TRAFFIC AND PARKING IMPACT ASSESSMENT OF A RESOURCE RECOVERY FACILITY

344 Park Road-Wallacia

Traffic and Parking Impact Report

19m SEMI TRAILER VEHICLE SWEEP PATH PLAN
SITE INGRESS / EGRESS MOVEMENTS
PROPOSED SITE ACCESS DRIVEWAY
PROPOSED RESOURCE RECOVERY FACILITY
344 PARK ROAD, WALLACIA

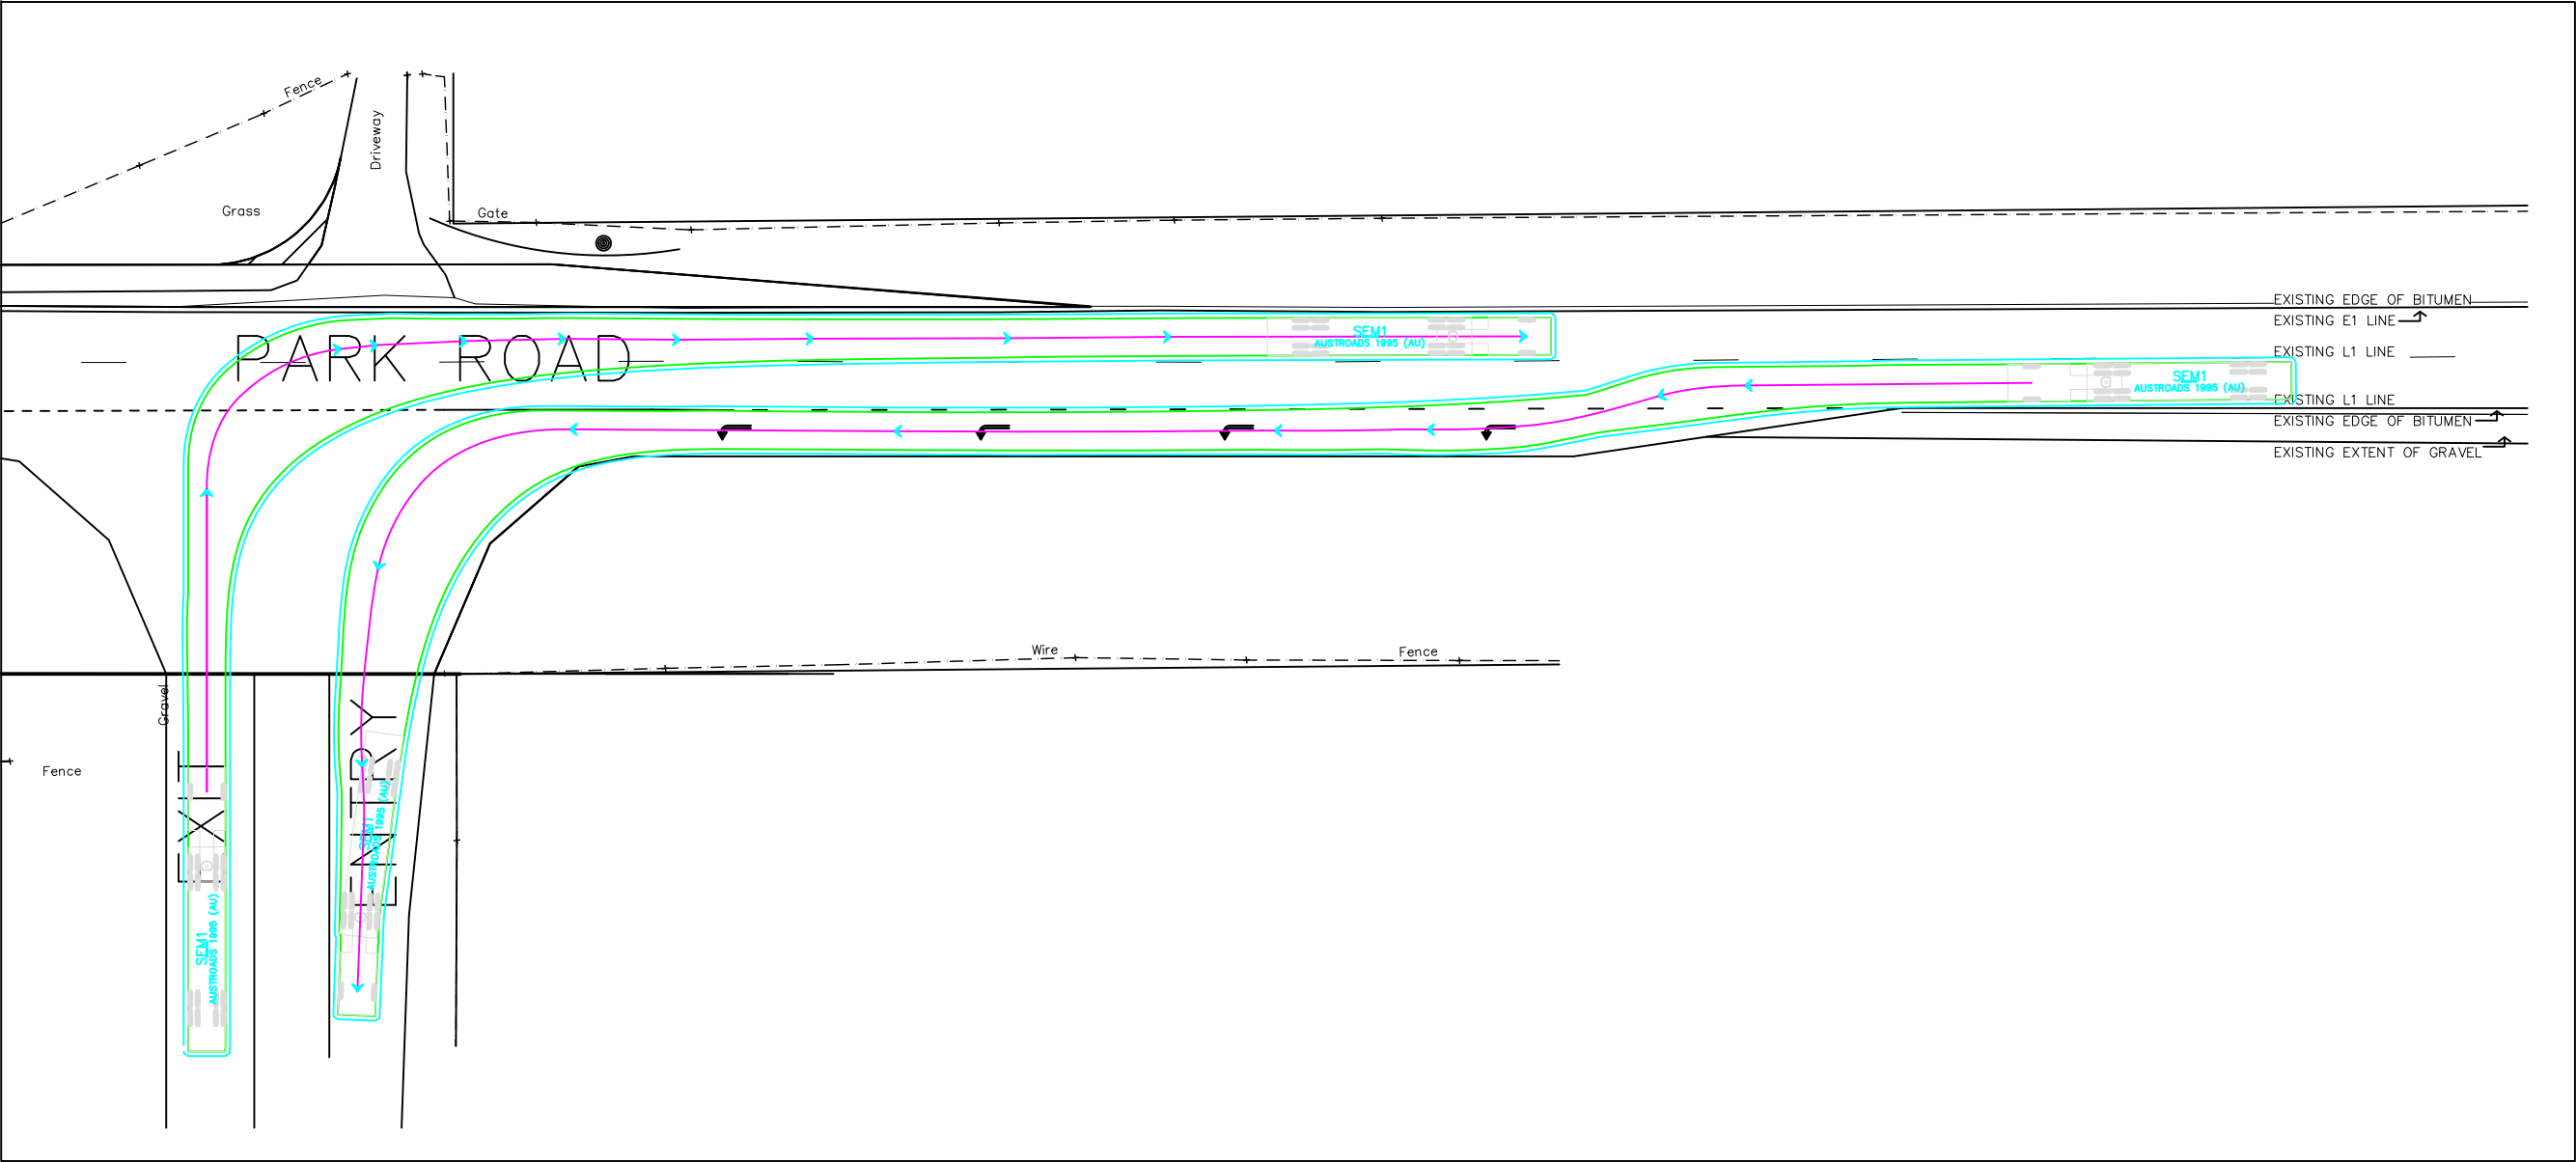
3. *The swept path of the longest vehicle (including garbage trucks, building maintenance vehicles and removalists) entering and exiting the subject site, as well as manoeuvrability through the site, shall be in accordance with AUSTROADS. In this regard, a plan shall be submitted to Council for approval, which shows that the proposed development complies with this requirement.*
4. *The largest vehicle to access the site is to be restricted to 19 metres.*
5. *All vehicles are to enter and leave the site in a forward direction.*
6. *All vehicles are to be wholly contained on site before being required to stop.*

In order to assess the suitability of the proposed site access arrangements, and in direct response to Item 3, a series of swept path plans have been prepared and are attached as **Appendix 2** for reference. These swept path plans illustrate the following:
